Drinking Water Audit Report

County:	Laois	Date of Audit:	23 rd June 2016
Plant(s) visited:	Convent Borehole Durrow No. 1 PWS	Date of issue of Audit Report:	1 st July 2016
	(1600PUB 1002)	File Reference:	DW2016/119
		Auditors:	Aoife Loughnane Pauline Gillard
Audit Criteria:	 The European Union (Drinking Water) Regulations 2014 (S.I. 122 of 2014). The EPA Handbook on the Implementation of the Regulations for Water Services Authorities for Public Water Supplies (ISBN: 978-1-84095-349-7) The recommendations specified in the EPA Drinking Water Report. EPA Drinking Water Advice Notes No.s 1 to 15.

Photo 1: Convent borehole - raised well-head

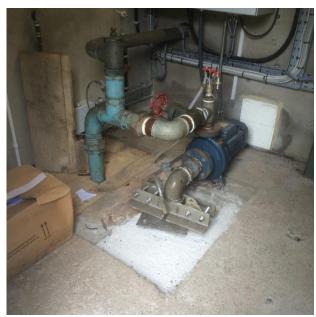
- e. On 31st December 2015, Laois County Council shut-down the water supply due to concerns about rising flood levels at the Convent borehole during a winter storm. While the ground surrounding the plant was not flooded, some floodwater entered the borehole though shallow subsurface flow. Irish Water notified the EPA that Durrow No. 1 PWS was shut-down from 31st December 2015 to 4th January 2016 due to flooding in the area. The supply was fed by Fermoyle WTP during the shut-down. Prior to bringing the Convent WTP back into supply, the borehole was purged and pumped to waste until the chlorine levels recovered, and microbiological samples of treated water were clear. In subsequent emergency works, Laois County Council raised the well-head by 18 inches to reduce the risk of ingress re-occurring.

- 1. Irish Water should ensure that all redundant boreholes are decommissioned in accordance with best practice guidelines, to prevent the risk of presenting a preferential pathway for the entry of contaminants to the aquifer.
- 2. Irish Water should ensure that all borehole linings, seals and well-heads are installed and maintained in accordance with EPA Advice Note No. 14: Borehole Construction and Wellhead Protection.
